FINAL ENVIRONMENTAL IMPACT REPORT

Riverfront Project

SCH NO: 2019110392

City of Santa Cruz
Planning and Community Development Department

attachments: Vehicle parked into Front St. Bike Lane, Example of dual stairs and ramp, End of Cathcart St. showing ramp around steps in urban river plan

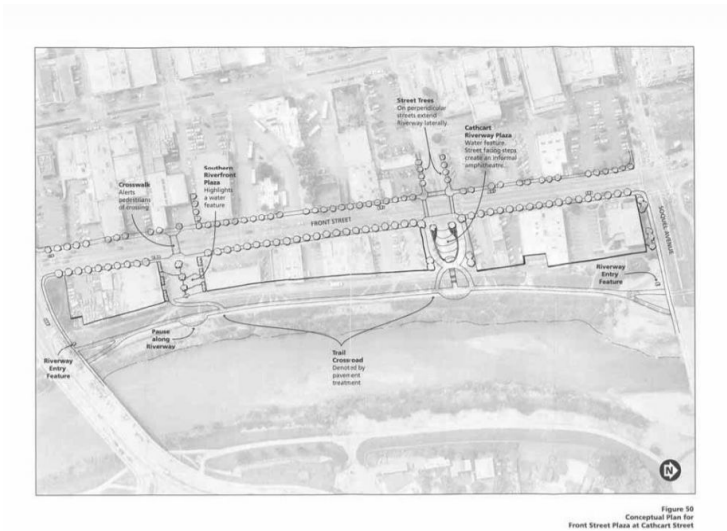
The current proposal -- showing wide steps leading from the end of Cathcart to the levee -- is an inadequate substitution for removing the current pathway. The project plans envision cyclists traveling between Cathcart and the levee either taking an elevator or walking their bikes up the steps on a "bike rail" -- a narrow incline built into the edge of the stairs. Thus, first, this means that their cycling would be interrupted -- they would have to become pedestrians trying to navigate this rail or using the elevator. Second, these would be very inconvenient options. It would be awkward and difficult at best to push a bike up the rail and control it down the rail. This incline would not be usable if one had a pannier on the railing side of their bike, had a bike trailer, had a recumbent, or had a heavy eBike. Those future residents using the levee to bike commute would have to take their bikes up and down the stairs every day because the entrance to their bike parking is off of Front Street. The alternative of using the elevator would also require dismounting along with waiting and going inside. The elevator would not be an available alternative when being serviced or when power is off.

The removal of the current bike ramp must be mitigated with a rideable alternative. There is ample room -- a 60-foot passageway -- in which to accommodate a rideable path. Attached is a sketch from the *River Plan* that appears to illustrate steps with ramps on either side from Cathcart to the River. Another model is the entrance to the Gateway Plaza from River Street consisting of a ramp to one side and stairs to the other (please see photo).

- B1-2 Impacts to Bicycle Transportation. The comment states that the DEIR fails to mention impacts on bicycle transportation. The comment states that the existing bikeable ramp from the top of the river levee to the site would be removed, that the proposed "bike rail" along the stairway to the levee is inconvenient and that a rideable alternative be provided. *Response:* Transportation impacts are addressed on pages 62 to 66 of Appendix B of the DEIR. On page 62, the discussion indicates that the Project is in proximity to transit, bike lanes, and multi-use paths. The commenter is correct in that the existing ramp from the levee to an existing parking lot on the Project site would be removed. However, as indicated in the comment, the Project proposes use of a "bike rail" along the stairway from the pedestrian paths to the river. The Downtown Plan does indicate that bicycle access shall be provided at the extension of Elm Street, but the Plan does not specify a preferred or recommended design method. Neither the City's Active Transportation Plan nor the San Lorenzo River Urban Design Plan provide specific recommendations for bicycle access in the vicinity of the Project site; see also Response to Comment B1-3. Because the Project provides bicycle access and does not conflict with a program, ordinance or policy addressing the circulation system as further explained in Response to Comment B1-3, a significant impact related to bicycle transportation was not identified. The DEIR text has been expanded to provide this discussion; see section 3.3 in the "Changes to Draft EIR" section of this document. The commenter's recommendation for a "rideable" alternative to the proposed Project bike rail along stairways is acknowledged, and will be further considered by City staff and decision-makers.
